## CJH Roof Membrane Replacement RFP Questions and Answers as of April 30, 2024

COLVILLE CONFEDERATED TRIBES  
 CHIEF JOSEPH HATCHERY  
 HATCHERY BUILDING  
 ROOF PLAN

COLVILLE CONFEDERATED TRIBES  
 CHIEF JOSEPH HATCHERY

HATCHERY BUILDING  
 ROOF PLAN  
 1/8" = 1'-0"

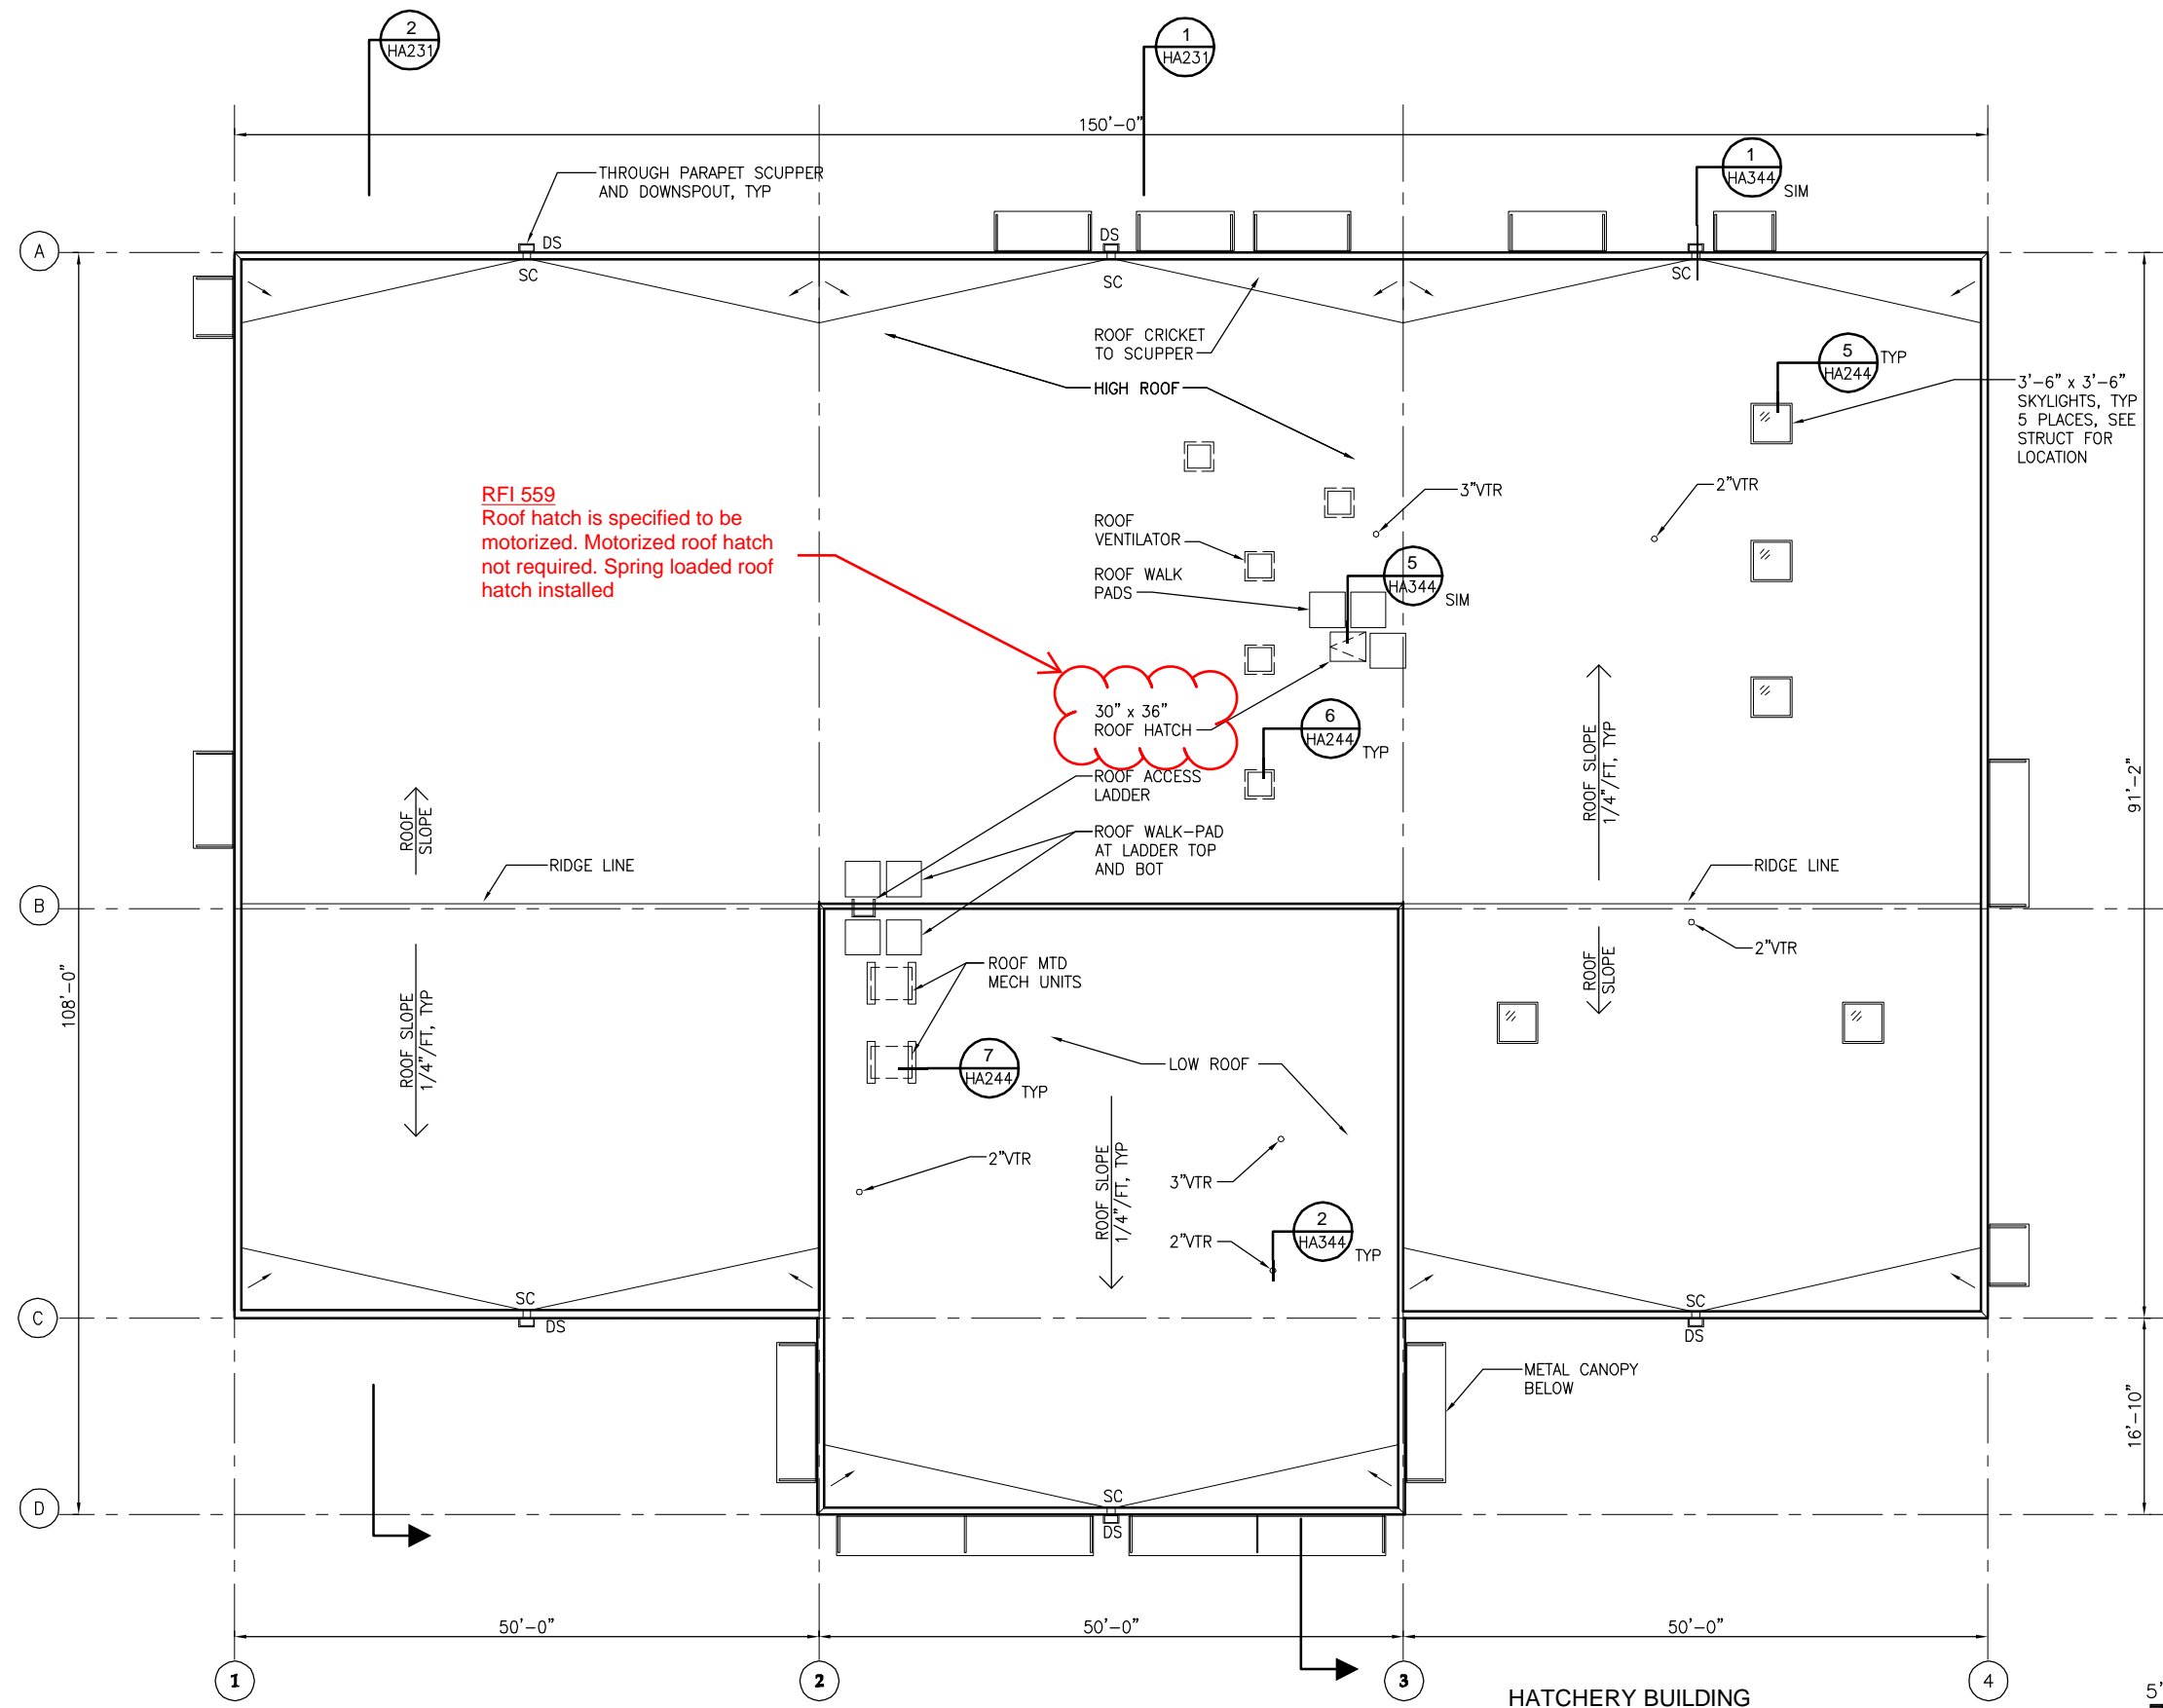
RFI 559  
 Roof hatch is specified to be motorized. Motorized roof hatch not required. Spring loaded roof hatch installed

OFFICE BUILDING  
 ROOF PLAN  
 1/8" = 1'-0"

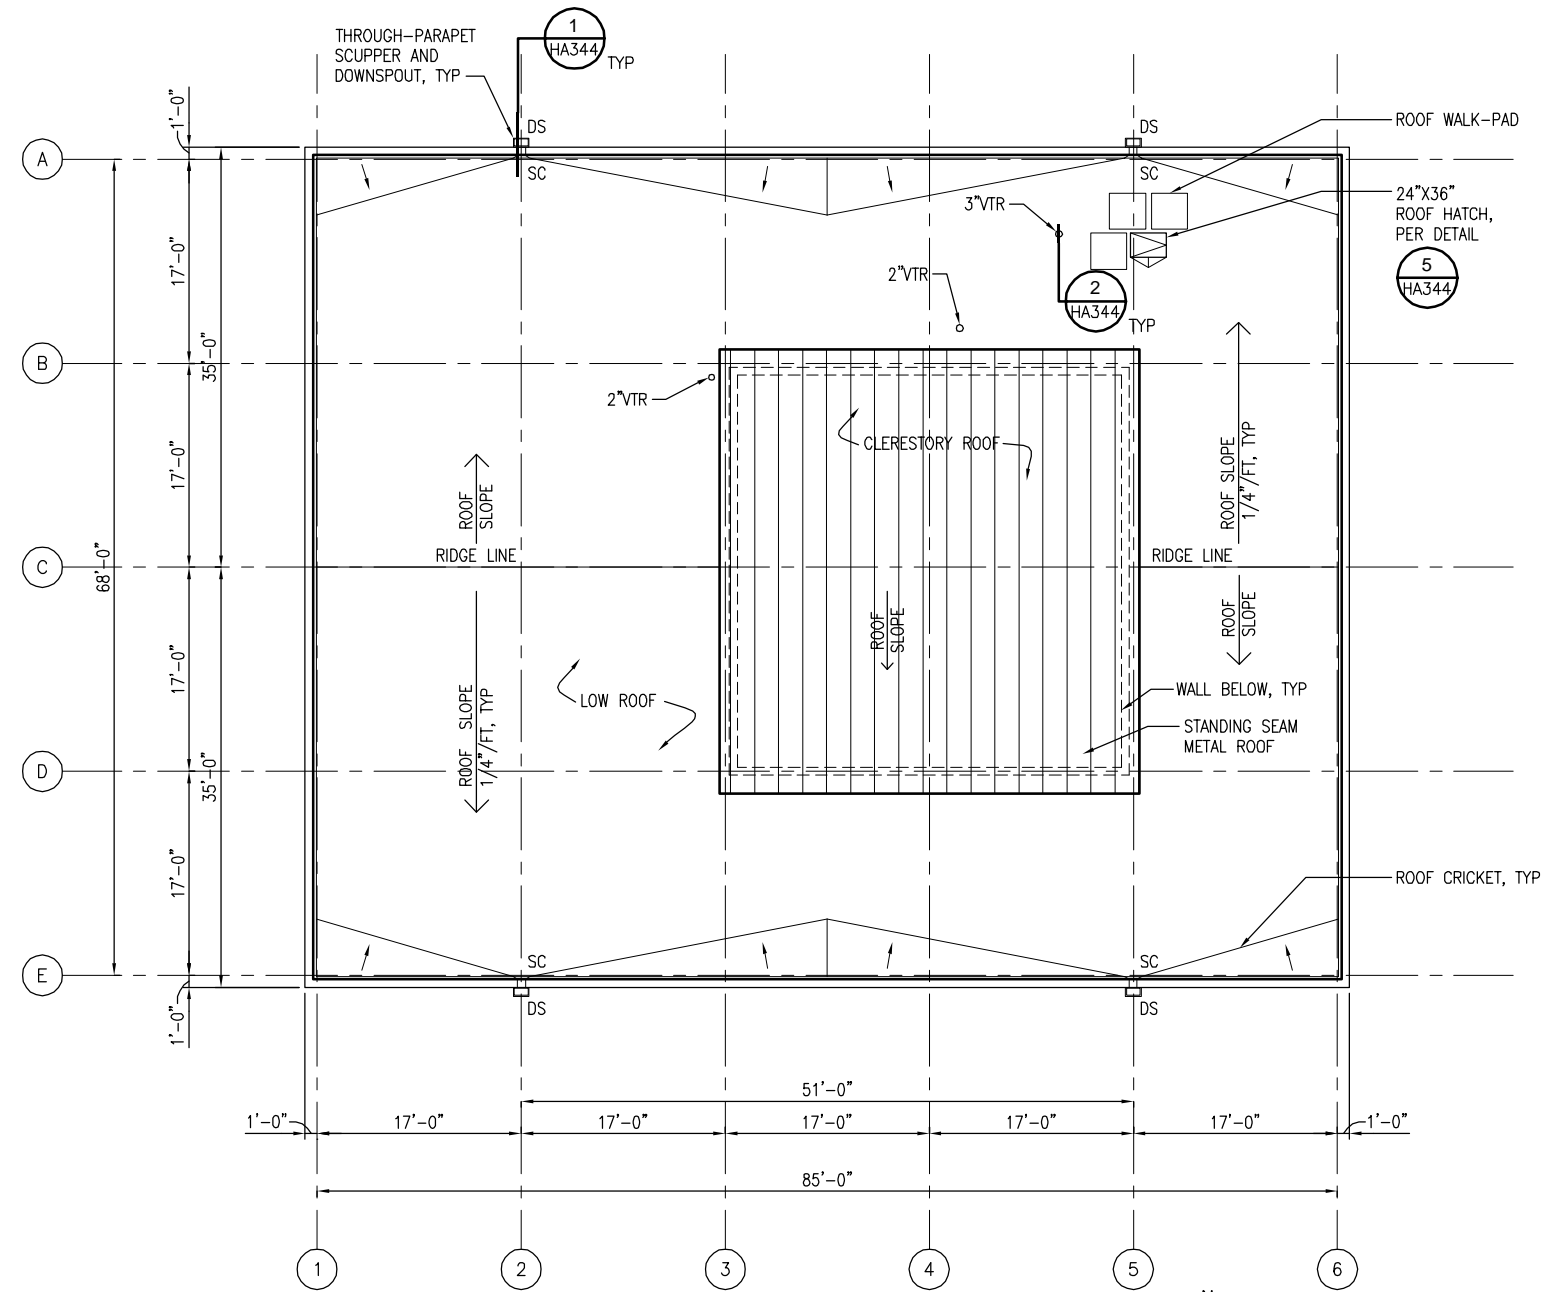
**RFI 570**  
 Membrane roof changed to fully  
 mechanically fastened roof system.  
 Exposed fasteners are not acceptable
